Subject: EPA Comments on Kansas City Board of Public Utilities, Nearman Creek Power Station, Kansas City, KS  
Round 7 Draft Assessment Report

**Subject:     Comments on Draft Coal Combustion Waste Impoundment Round 7 –  
Dam Assessment Report (Site #009), Nearman Creek Power Station,  
Coal Ash Pond Dike, Kansas City Board of Public Utilities, Kansas City,  
Kansas**

## Coal Combustion Waste Impoundment Round 7 - Dam Assessment Report (Site #009)

*Nearman Creek Power Station*  
*Coal Ash Pond Dike*  
*Kansas City Board of Public Utilities*  
*Kansas City, Kansas*

Figure 4.2.1-1: Configuration of the Ash Pond at the KCBPU Nearman Creek Facility

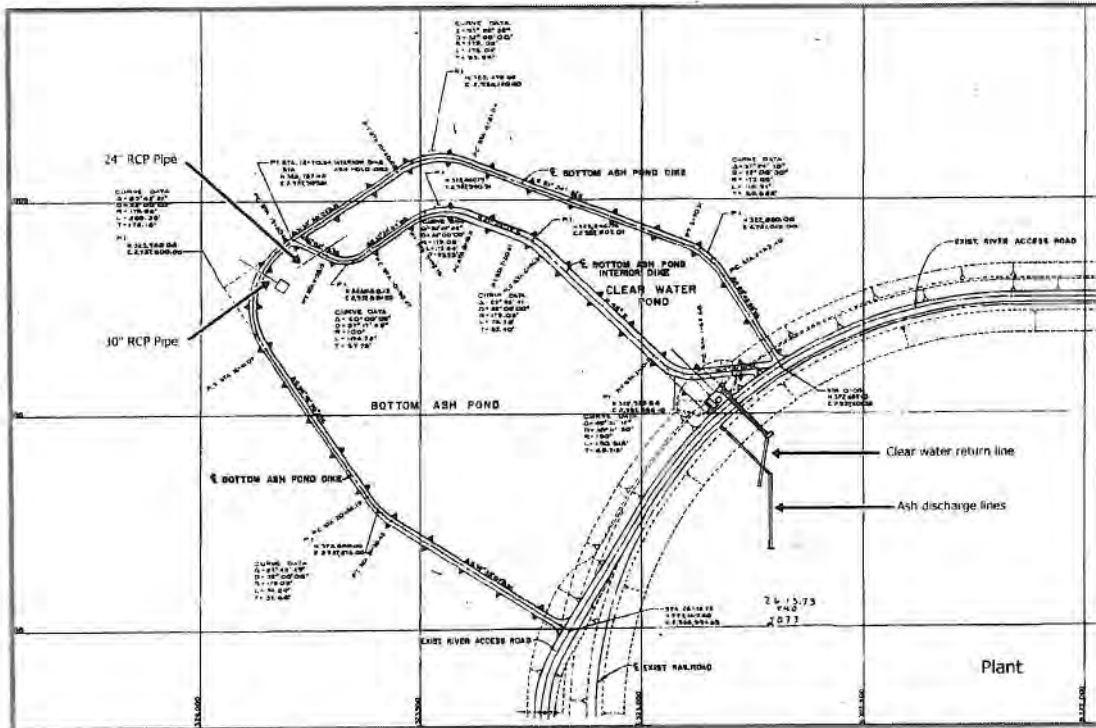
The original design included a 30-inch mid-depth discharge pipe regulated with a mechanical gate. The purpose of this pipe was to permit inflow into the pond in case of flooding to help stabilize the embankments during construction and prior to operational start-up. This pipe has reportedly been closed since construction of the pond was completed. When the mechanical gate started leaking, plant management decided to close this pipe using an inflatable balloon system. However, a small amount of leakage was observed from this pipe during the site visit, raising questions regarding the reliability of these closure mechanisms.
